Planning Committee

Wednesday the 20th March 2019 at 7.00pm

Update Report for the Committee

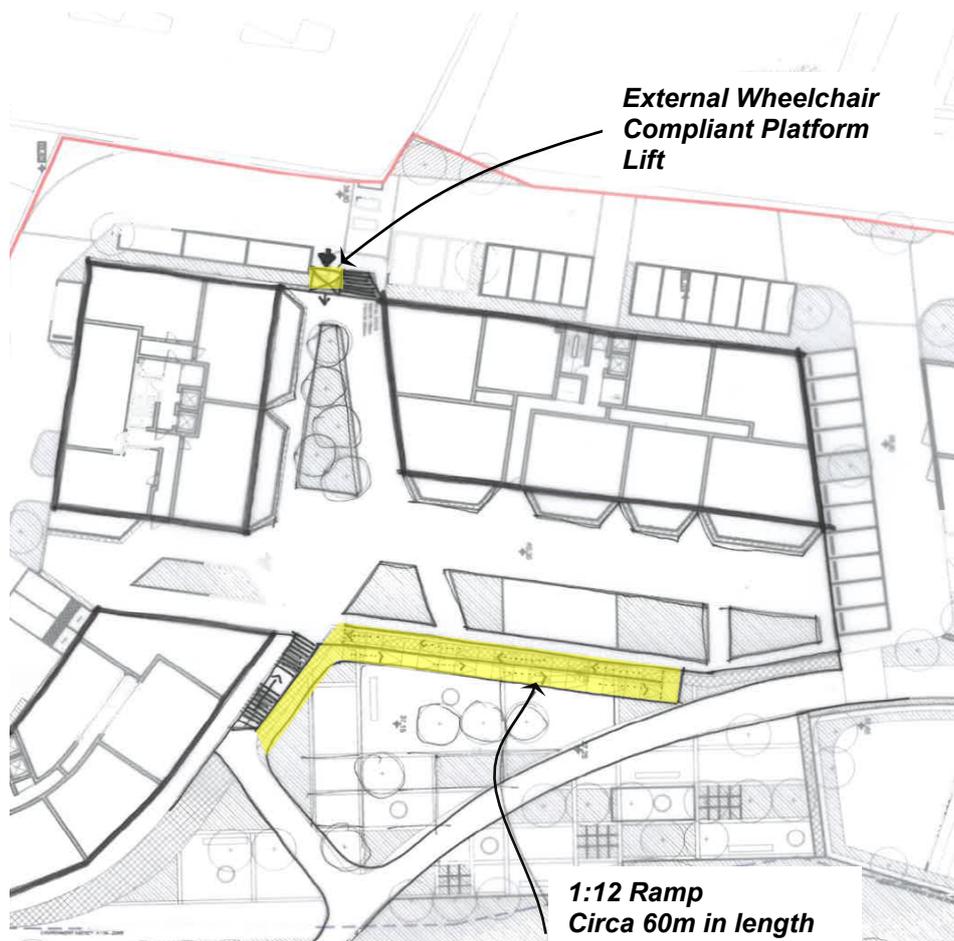
- Concerned by fact that there is no ramped access to the 'social' space on the Podium and there is no alternative exit for those who have had to use the lift, in the case of emergency. Please consider making it a requirement that this is amended in some way.
- Is the car parking to be allocated to each flat?
- What parking provision is there for visitors to Residents?

However following the comments of the Ashford Access group about the lack of a ramp up to the podium, the developer has agreed to put a ramped access from the riverside open space. This ramp will be approximately 60metres in length.

An external wheelchair compliant platform lift will also be provided adjacent to the set of steps on the west edge of site between blocks B and C leading directly off the main access street. See sketch below.

The materials and detailed design of the disabled access ramp and platform lift will be covered by extra conditions.

The inclusion of the ramp has a negligible impact on the provision of open space. It results in a slight reduction of 63sq.m in public open space. This still leaves 1507sqm of public open space. This is still an increase in open space compared to the scheme presented to committee in January.
